SS 1033870 Discontinuation of FCCC's Use Of Height Control Valve 16-16925-000/001

Applicable Vehicles<- FCCC MC chassis built with a No suspension dump option

Figure 1

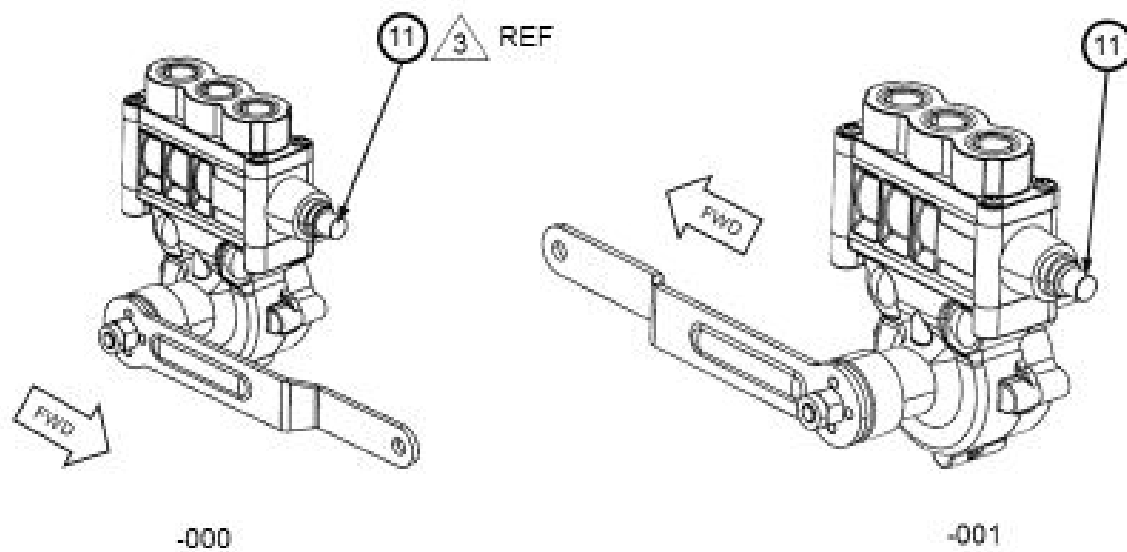
Issue<- The replacement valve(s) 16-213213-000/001 has an extra port on the side of the valve. On FCCC MC Chassis with non dump suspension systems do not have a dump control signal line to insert into this open port. If left open, the valve will leak air.

Solution<- Use plug part number 23-1445-001 and insert into the open control port on the new valve (see to Figure 1 reference #11). Then install the valve and the rest of the hoses as normal.

DETAIL: NO-DUMP VERSION OF VALVES
FROM DUMP VERSION
BY PLUGGING PORTS WITH PTC PLUG 23-14415-001
